÷N COMP Wiring Diagram & Build Instructions

tested & works, Aug 2010 (Guy D2)

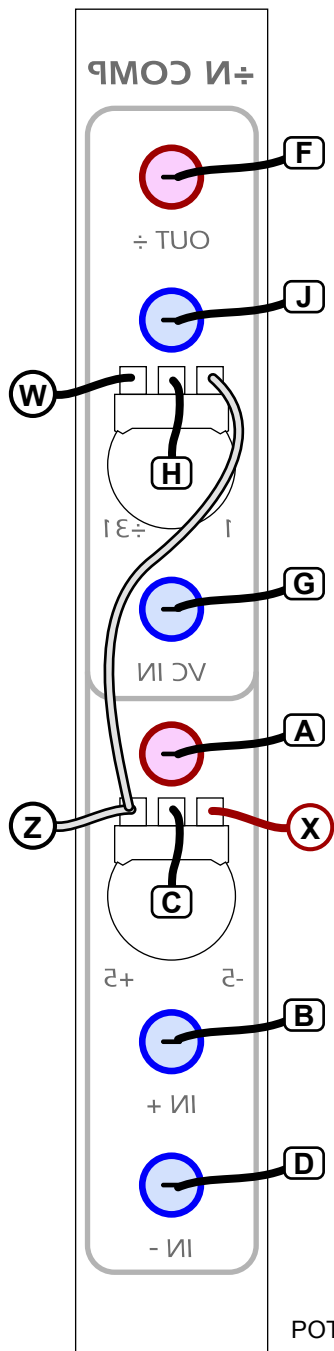
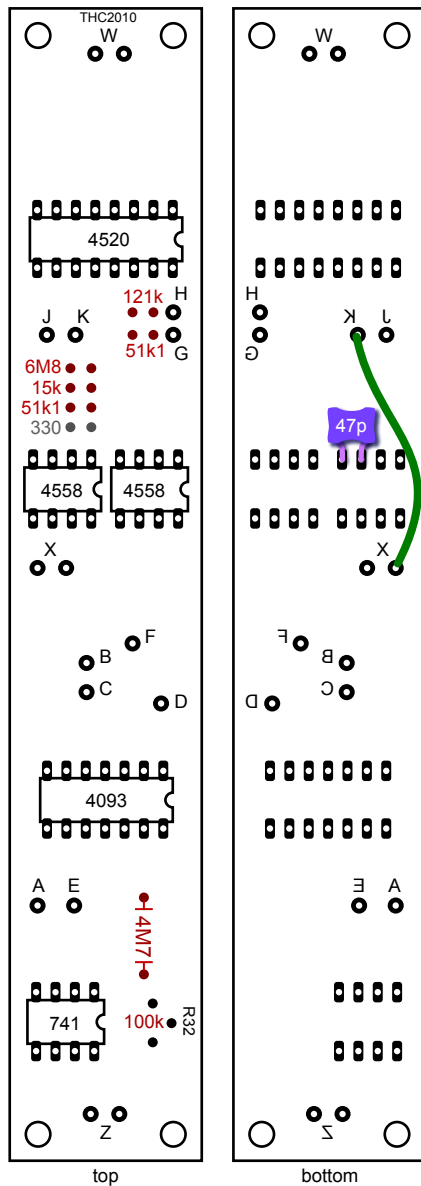
Do NOT install:

- C3 (near 741)
- R3
- R12
- R18

On the solder side, install:

- jumper between pads K & X.
- 47p Mica cap over p1 & p2 of the left 4548.

PCB changes

On the THC2010 edition of the NCOM (issued by Jon, July 2010), replace the following resistors:

new	on board
R13	51k1	47k
R14	121k	110k
R15	51k1	47k
R16	15k	47k
R17	6M8	47k

(R13, R14, R15 = 1%)

Use 4M7 for R30 (unlabeled on the pcb)
